Westinghouse's Responses to the NRC's Requests for Supplement Information
(RSIs) and Observations (OBSs)
(Non-Proprietary)

October 2020

This request for supplemental information identifies information needed by the NRC staff (the staff) in connection with its acceptance review of the SENTRY™ Dry Storage System application to confirm whether the applicant has submitted a complete application in compliance with regulatory requirements.

Figure 2.1 Weight change and residual compressive strength of siliceous gravel and limestone concretes as a function of temperature.

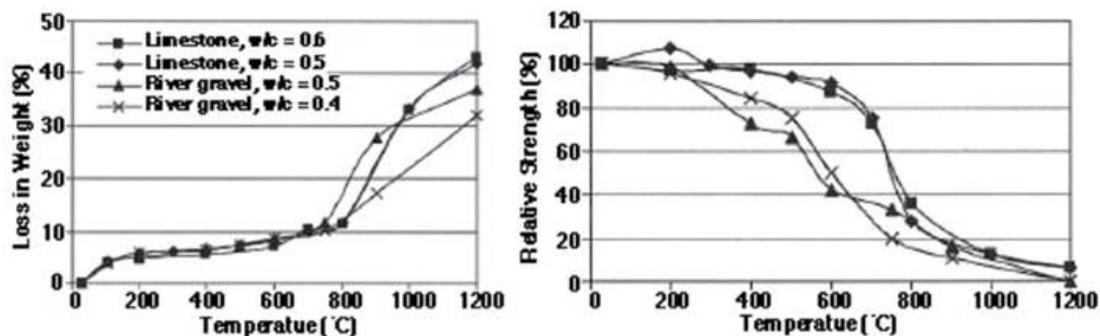
1. A technical basis that demonstrates that a bulk average concrete temperature exposure of 350°F (where the surface may reach as high as 558°F per SAR Figure 5.4-14) will not decrease strength and lead to moisture loss to an extent that could prevent the overpack from fulfilling its structural and shielding functions.
2. Clarification of what defines the extent a "local" area (i.e., area and depth affected), and a demonstration that the exposure of the concrete overpack to conditions where a local area reaches 650°F will not prevent the overpack from fulfilling its structural and shielding functions.

- This approach considers the definition of local area in ACI 349-13, "region of structure exposed to elevated temperature that may affect concrete performance and stress distribution in the immediate area, without changing the overall component or member behavior". NUREG/CR-7031 "A Compilation of Elevated Temperature Concrete Material Property Data and Information for Use in Assessments of Nuclear Power Plant Reinforced Concrete Structures" includes the following figure:

The figures above show how weight and strength do not substantially change in ordinary concretes exposed to temperatures varying between the long term limit (176 °C) and the short term limit considered for local areas (650 °F, i.e. 343 °C). Due to those minimum variations, shielding and structural behavior is minimally affected in the zones reaching these local temperatures that, on the other hand, are less than half the thickness of the concrete shell. The other half of the thickness is under the short-term bulk temperature limit and, therefore, it can be concluded that this exposure will not prevent the overpack from fulfilling its structural and shielding functions and the definition of local area is properly applied.
